Item 4.**Development Application: 29-33 Bourke Road, Alexandria****File No.:** D/2018/360**Summary**

Date of Submission:	12 April 2018 Amended drawings and additional information received on 15 August 2018.
Applicant:	Sutherland & Associates Planning Pty Ltd
Architect:	Cottee Parker JPRA Architects
Developer:	Tipalea Partners
Owner:	Tipalea Private No. 17 Pty Ltd
Cost of Works:	\$44,130,404
Zoning:	The site is zoned B6 Enterprise Corridor. The proposed development is defined as 'office premises', 'food and drink premises' and 'shop' all of which are permissible with consent.
Proposal Summary:	<p>The application seeks consent for demolition of the existing building, excavation and construction of a four storey mixed use building comprising basement level car parking, a shop and food drink premises at ground floor with office premises to the rear and on the upper three levels.</p> <p>The application is Integrated Development requiring the approval of Water NSW pursuant to the Water Management Act 2000. General Terms of Approval have been issued by Water NSW.</p> <p>The development application is being referred to the Local Planning Panel for determination as a Public Benefit Offer a

Figure 21: SDCP 2012 Liveable Green Network and Through-site link

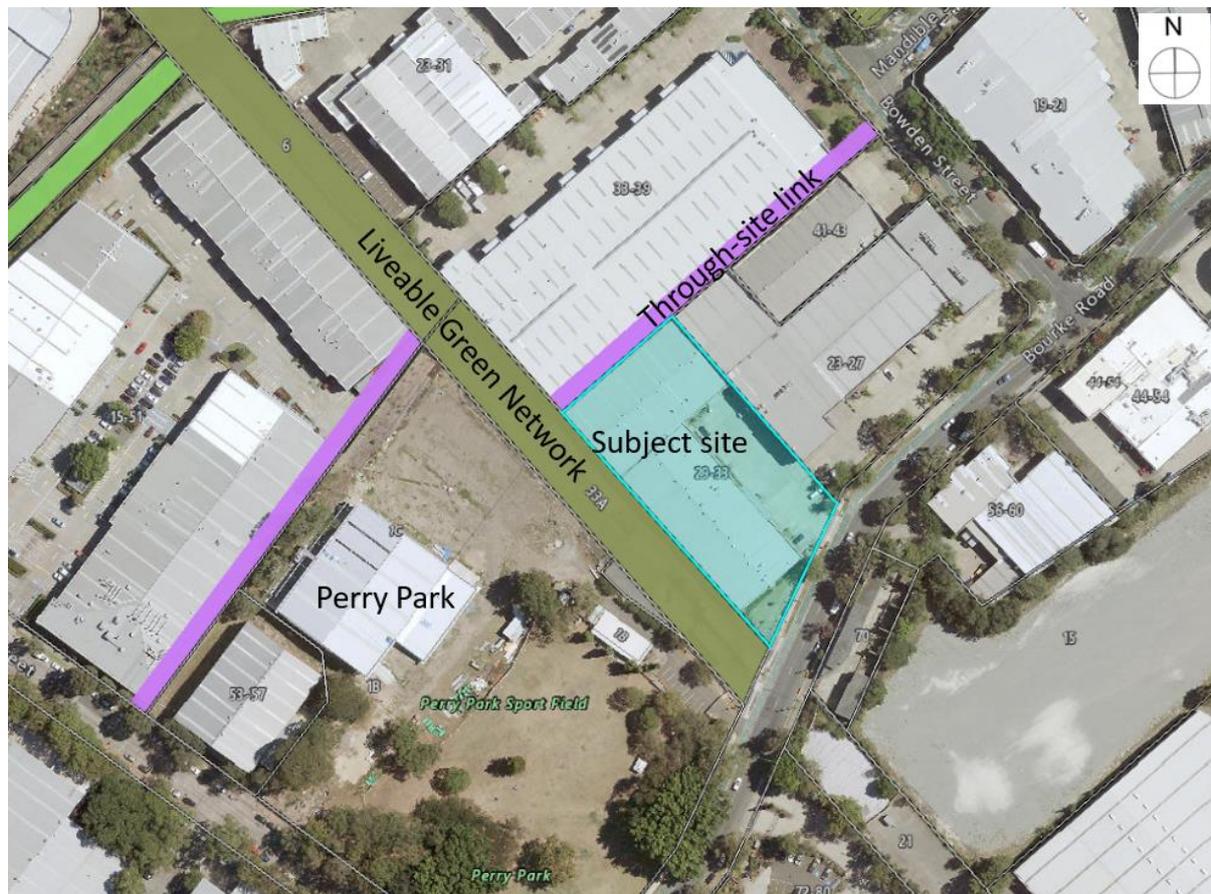
- 44. Section 5.8 (Southern Employment Lands) of the SDCP 2012 identifies the LGN and a through-site link adjacent to the subject site's south-west and north-west boundaries, respectively, as shown in Figure 21:

45. Section 5.8.2.2(9) of the SDCP 2012 requires the provision of side and rear setbacks that:
- (a) Ensure overland flow paths are not blocked or diverted;

46. Section 5.8.3.3 (1) of the SDCP 2012 requires new development along the LGN to:
- (a) Maximise opportunities for surveillance;
 - (b) Provide interest and minimise blank walls and incorporate building entries and large windows every 20m;

- (c) Provide a minimum of 25% of active frontage to the LGN.
47. Provision (2) of Section 5.8.3.3 of SDCP 2012 requires setbacks and building alignments to be consistent with the *Public domain setbacks map*, *Through-site links map* and Table 5.15 Landscape setbacks for the LGN.

In accordance with Table 5.15, as the water channel is closed, a setback of 5m measured both sides of the centreline of the pipe is required. The identified LGN is approximately 20m wide with the pipe in the centre, and as such there is no setback required for the proposed building from the future LGN.

Figure 22: Ground floor plan with location of proposed substation indicated in red

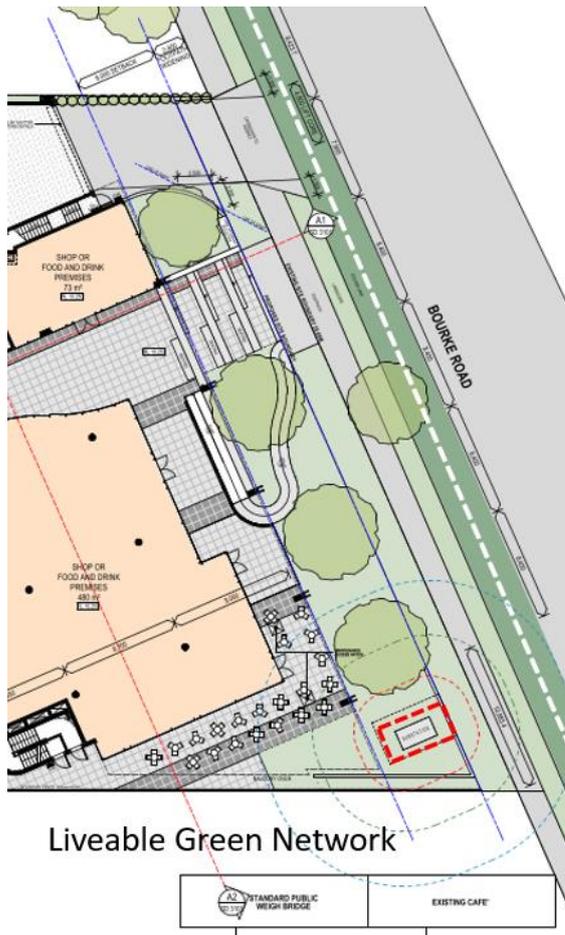
56. One of the issues identified with the proposal by Council staff and the Design Advisory Panel is the location of the kiosk substation. The substation is proposed to be located in the southern corner of the site within the Bourke Road front setback. This is considered to be a very prominent corner and is adjacent to the future LGN, as shown in Figures 22 and 23. The proposed location is considered to detract from the design quality of the development.

57. The inappropriate location of the substation was raised with the applicant in a letter dated 24 July 2018, and in a meeting held with Council staff and the applicant on 19 July 2018. It was recommended that the substation be incorporated in to the building through a chamber style substation.
58. Subsequently, the location of the substation was not amended with the following justification provided by the applicant:

The concerns about the location of the substation are noted, however, due to the design and access parameters of Ausgrid there are no alternative locations within the building where it could be relocated to. The provision of the facility inside the building would have a significant adverse impact to the Bourke Road façade as it would introduce a large blank component to the façade which would remove activation of the ground floor plane. Having regard to these constraints and impacts, the proposed location of the substation within a generously landscaped pocket is considered to represent the best possible outcome in the circumstances.

Figure 24: Deep soil planting calculations

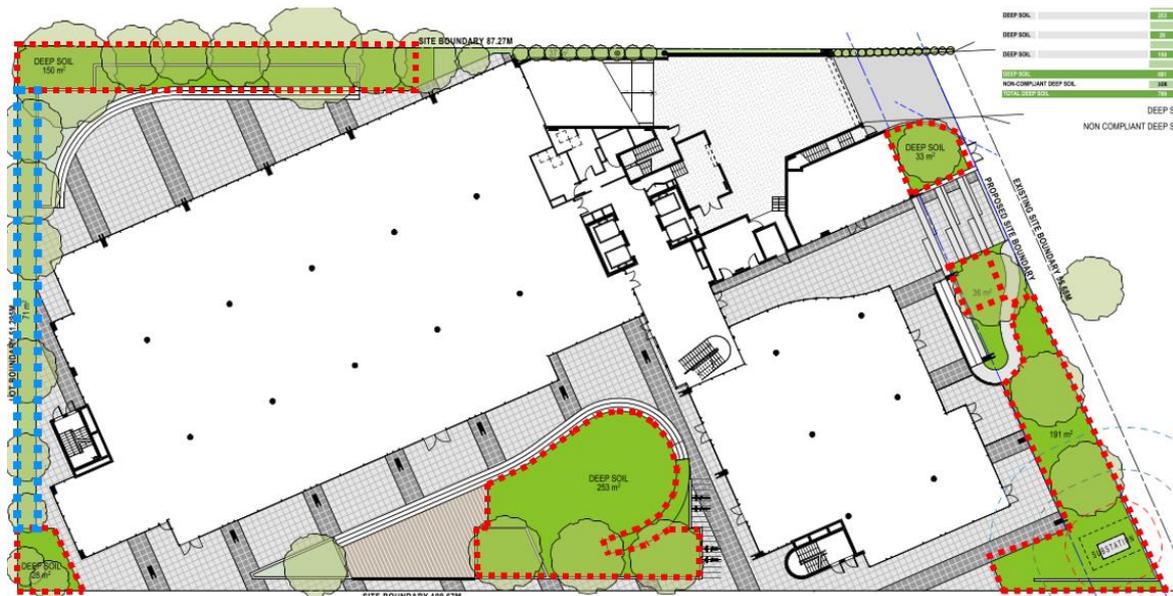
75. Section 5.8.2.5.1 of the SDCP 2012 stipulates that where a site is within the B6 Enterprise Corridor zone, a minimum of 15% of the site area is to contain deep soil planting. This equates to 735sqm being required to be provided for deep soil to the subject site. The minimum dimension for deep soil planting is 3m in any direction.

76. According to Council officer's calculations, the proposal provides approximately 663sqm (13.5%) of deep soil planting. It is noted that this includes the area where the substation is currently located. Therefore the recommendation to delete the substation also results in an increase to the deep soil planting.

77. The areas which have been counted towards deep soil are shown outlined in red in Figure 24. The landscaped strip running along western side boundary is approximately 1.6m wide (outlined in blue in Figure 24) and therefore was excluded in the calculation of deep soil.

78. With the inclusion of the 1.6m wide landscaped strip, the total deep soil planting is approximately 741sqm or 15.1% of the site area. It is considered that this landscaped strip can support tree planting. In addition, it is located adjacent to the future-through site link. As such there is opportunity to provide further contiguous deep soil in this area once the adjacent site is redeveloped. In light of the above, the minor non-compliance with Section 5.8.2.5.1 of SDCP 2012 is supported in this instance.

Figure 25: Land to be dedicated to Council for footpath widening along Bourke Road

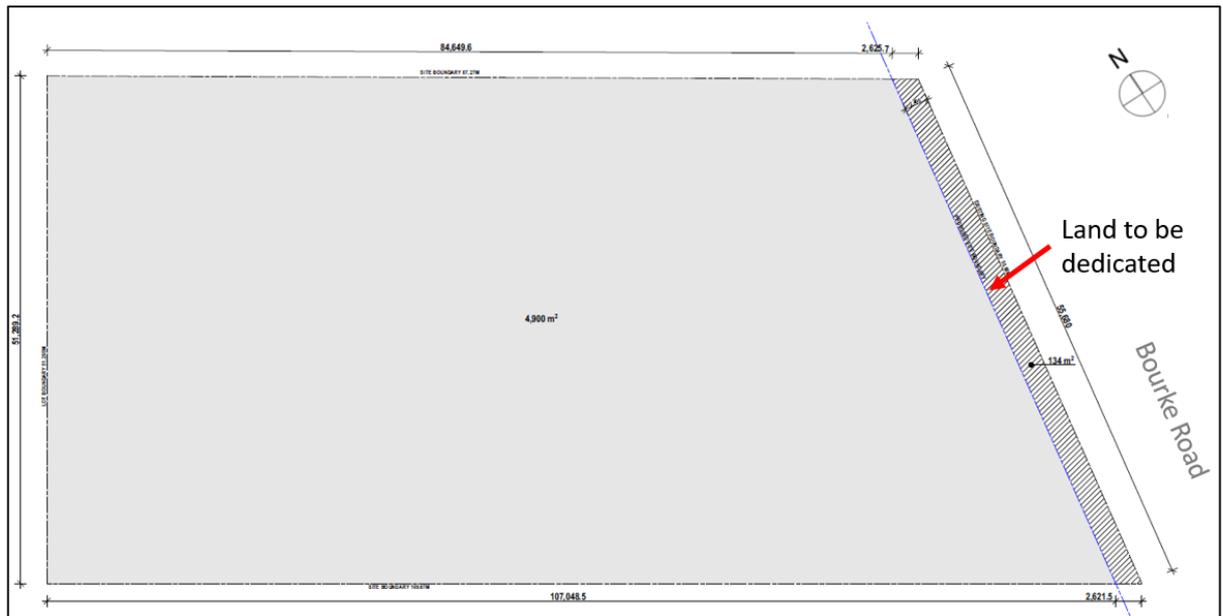
79. A draft VPA has been prepared in relation to the proposal and includes the following public benefit:
- Dedication of along the Bourke Road frontage of the site towards footpath widening. The piece of land is approximately 2.4m wide, 55.5m in length and has an area of approximately 134sqm, as shown in Figure 25.
 - Embellishment of the land to be dedicated with asphalt finish.
 - A monetary contribution of \$416,835.62 towards the delivery of public infrastructure within the Green Square Urban Renewal Area.
